Change Order

Williamson County
Children's Advocacy Center
1811 SE Inner Loop
Georgetown, TX 78626

Change Order Number: 011

Change Order No. 011 includes the below listed Vaughn Change Proposals No. 0013, 0019, 0020, 0021, 0022, 0023, 0024, 0025, and 0026. Additionally, a credit is included for Williamson County Utilities Invoice #120328 for utilities at the existing CAC building. This is deducted from Vaughn's Fee for the following Change Proposals. For Vaughn Project No. 2860-01.

A-8.03

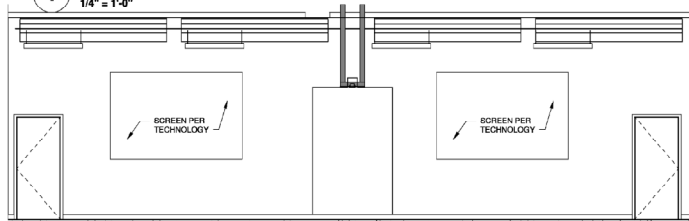
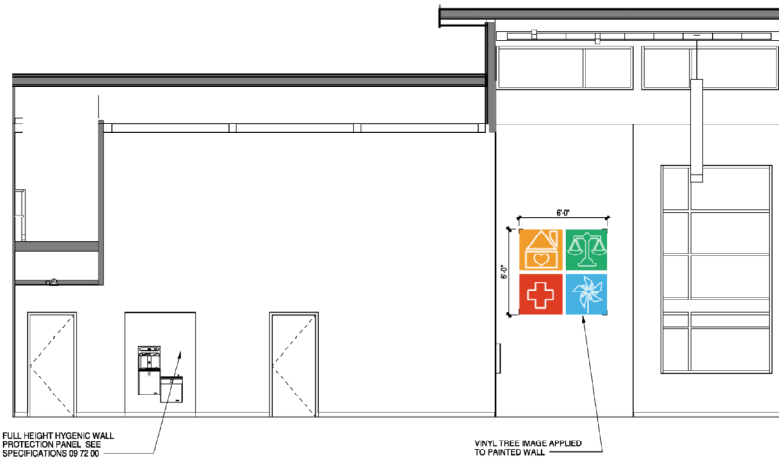
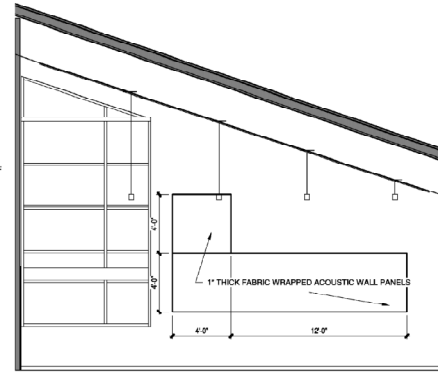
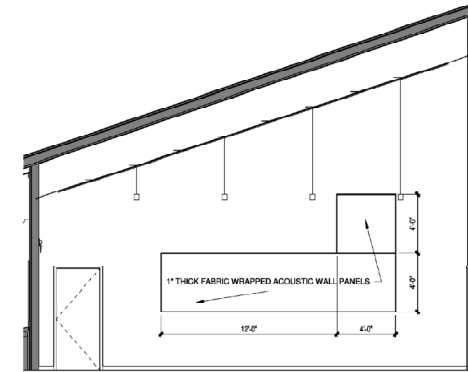
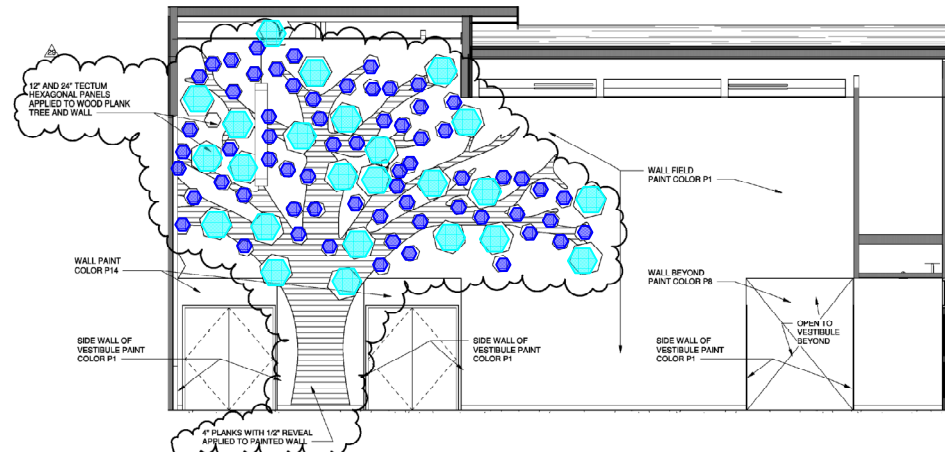
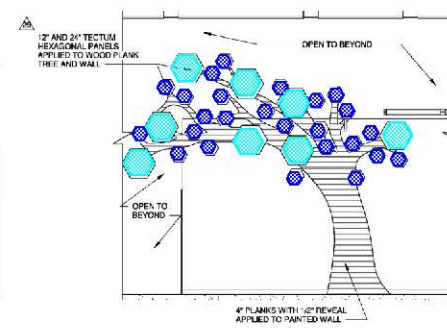
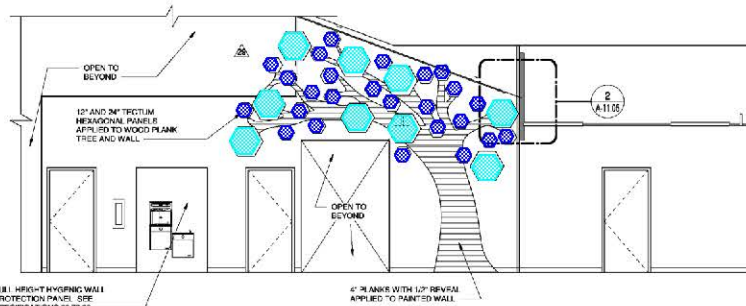
Additionally, this change proposal includes a modified scope from what is indicated in ASI-028. The body of the trees will be stain-grade maple over plywood in lieu of 4" planks with 1/2" reveal. The tree leaves will be as indicated in ASI-028. The tree in Family Advocate Interns Room 108 (detail 1/A-8.03) is not included in this proposal as it is deleted per Owner request in RFI 108.

- 1 - Tectum Hexagon 12" (small) - 65 EA
- 2 - Tectum Hexagon 24" (large) - 24 EA
